DOE/EIS-0161-Vol. 3

Final Programmatic Environmental Impact Statement for Tritium Supply and Recycling

Comment Response Document

United States Department of Energy
Office of Reconfiguration

Plant Totals		25,317.0 TONS		138.0 TONS	12,731.0 TONS	1,186.0 TONS	1,052.0 TONS	40,425.0 TONS

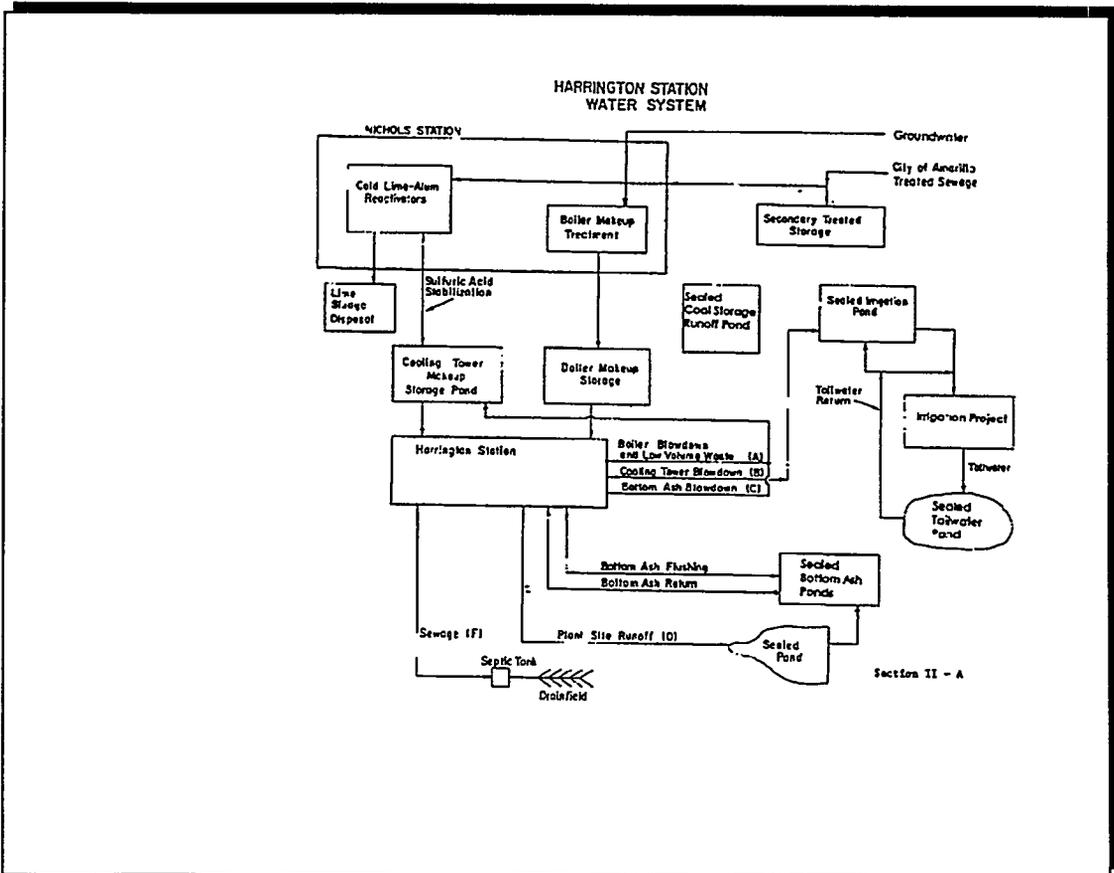
Plant	Summary of calculations	Emissions Tons/yr EPA	SO ₂ Fuel Analysis	VOC AP 42	NO _x STACK TEST	CO AP 42	PM AP 42	Total Emissions
Unit 1	1-1	22,730 TONS		70 TONS	6,872 TONS	596 TONS	516 TONS	20,764 TONS
	2-1	22,567 TONS		69 TONS	5,658 TONS	590 TONS	510 TONS	19,816 TONS
Auxiliary Boiler	AMC 8-8	0 TONS		0 TONS	0 TONS	0 TONS	0 TONS	0 TONS
	1-3	0 TONS		0 TONS	1 TONS	0 TONS	0 TONS	0 TONS
Emergency Gen. 1	2-3	0 TONS		3 TONS	0 TONS	0 TONS	0 TONS	0 TONS
	2-4	0 TONS		3 TONS	0 TONS	0 TONS	0 TONS	0 TONS
Emergency Gen. 2a	1-2	0 TONS		0 TONS	0 TONS	0 TONS	0 TONS	0 TONS
	2-2	0 TONS		0 TONS	0 TONS	0 TONS	0 TONS	0 TONS
Emergency Gen. 2b	1-2	0 TONS		0 TONS	0 TONS	0 TONS	0 TONS	0 TONS
	2-2	0 TONS		0 TONS	0 TONS	0 TONS	0 TONS	0 TONS
ASH SYSTEMS	Unit 1	0 TONS		0 TONS	0 TONS	0 TONS	0 TONS	0 TONS
	Unit 2	0 TONS		0 TONS	0 TONS	0 TONS	0 TONS	0 TONS
ASH PITS	ASH	0 TONS		0 TONS	0 TONS	0 TONS	0 TONS	0 TONS
	ASH	0 TONS		0 TONS	0 TONS	0 TONS	0 TONS	0 TONS

Figure 4
Cumulative and Annual Employment Patterns
During Reactor Construction

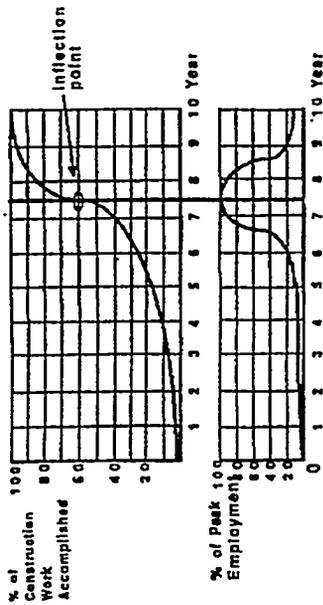
For example, the 1991 DEIS listed operational employment figures for the HWR at SRS (1250 workers) that also included the work force required to concurrently operate all three of the K, L, and P reactors.³⁵ Further, the operational employment at the LWR and MHTGR both included an undetermined number of waste management workers. This significantly overstated the number of reactor operations workers

Based on cumulative labor shown in the upper curve in Figure 4, one can derive the lower curve which shows incremental annual employment for constructing any of the three reactor projects. This curve shows annual employment, as a percent of peak employment, in each of the 10 years of the construction phase. For example, for an HWR, peak construction employment at all three potential sites is about 2,500 workers. This number of workers would be employed in year 8. In year 5, which has employment levels of 16.6% of peak employment, $(.166)(2500) = 415$ workers are employed in construction.

The total effort calculations in Appendix N which are based on this employment curve are incorrect. However, the basic employment curve can be used to calculate the annual employment associated with construction of each of the NPR options. Figure 4 shows the cumulative employment curve described in Appendix N.
